Avolites LTD Engineering Change Notice

ECN title	D9-215 and 330 PCIe cable protection	
ECN Number	ECN-214	
Related Product(s)	All D9 consoles up till and including SN 92-0034 or 93-0020	
Date / Author	27/06/2022	JB Toby
Reasons for ECN	Cable can get damaged on internal structures affecting the GPU	
Parts required	8200-0214 D9 PCIe protector set	
Tools required	No. 2 posidrive short and ideally a right angle Posidrive No.2	
Estimated time	10 minutes for inspection, 30 minutes for fitting protection

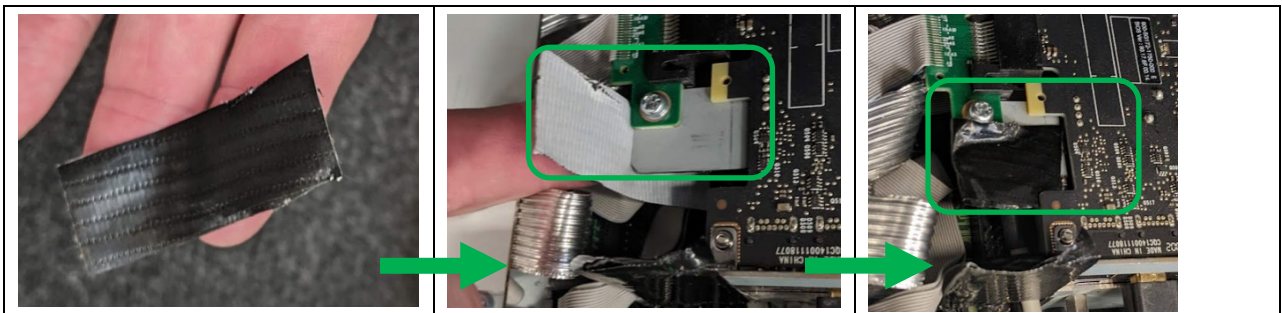
Locate the PCIe loom on the Motherboard frame.

Check that the cables are not touching the frame parts (Red rectangles above) or have been damaged where they touch the retainer (blue rectangle above).

Either fit the insulator kit (see below for instructions) or fit some gaffer tape as a temporary measure As instructed below.

1.2   Temporary PCIe cable protection

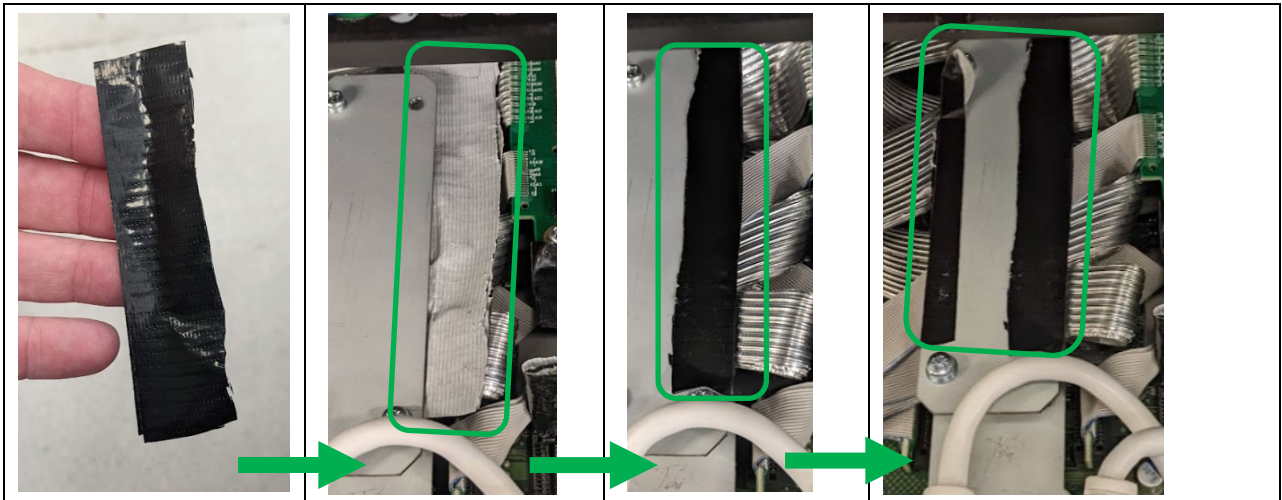
Use two layers of gaffer tape approximately 50x40mm (2 x 1.57").

Fit behind the PCI slot holder as shown, then fold against the frame.

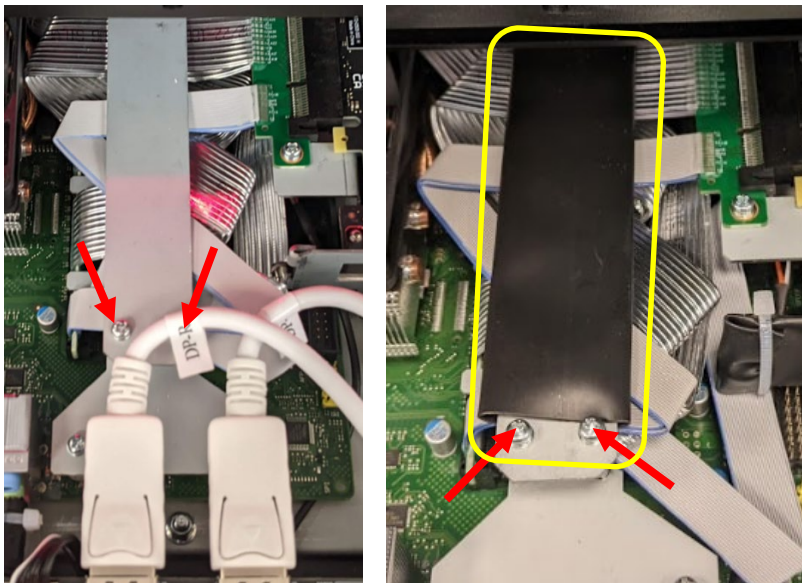
Use two layers of gaffer tape approximately 50x20mm (2 x .78").
Fit behind the PCI Connector as shown, then fold against the frame.

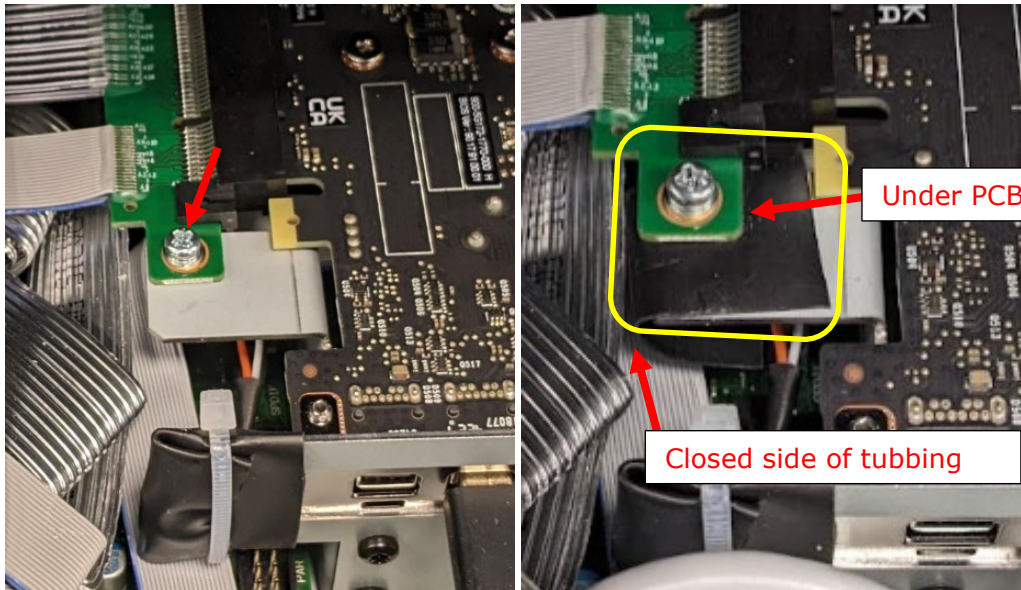
Create two layers strips of gaffer tape approximately 110x20mm (4.3 x 0.78").

Fit between the PCIe cable retainer and the PCIe cable, then fold over the PCI cable retainer, repeat this on the other side.

2.1 PCIe cable retainer

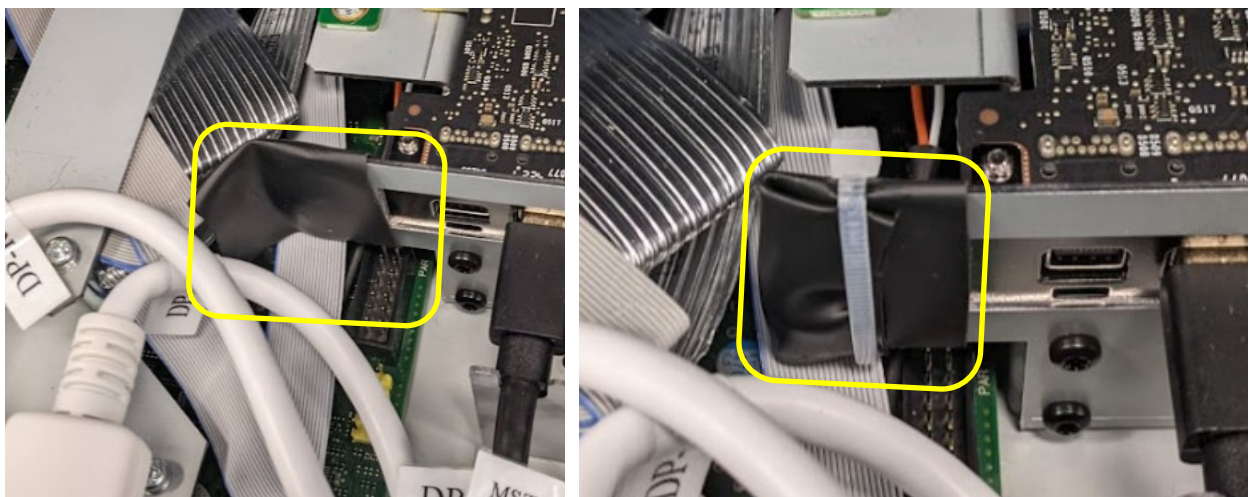
Remove the two screws as indicated, then slide the longest section tubing over the cable retainer, then refit the screws and tighten to 0.6Nm (4.4 inch lbs).

2.2   PCIe Connector

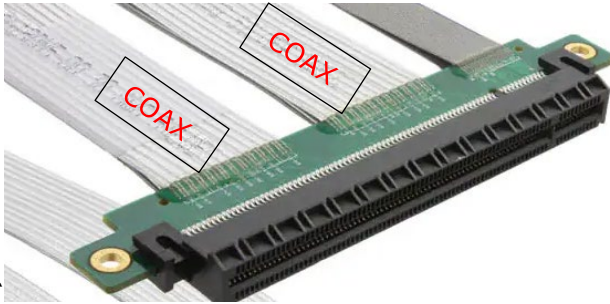
Remove the screw holding the PCI connector.

Fit the Open tubing section Under the PCB with the hole over the screw location, so that the closed section of the tube is on the Left-hand side, Refit the screw and tighten to 0.6 Nm (4.4 inch lbs).

Under PCB

Closed side of tubbing

2.3   PCIe Slot

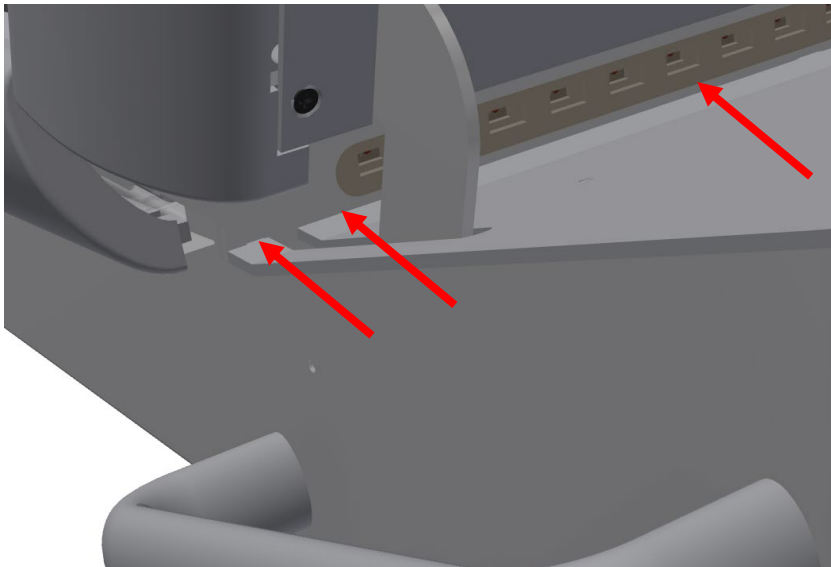
Fit the remaining tubing over the PCI slot retention tab as shown below, then fold the end over and fit a cable tie to retain this.
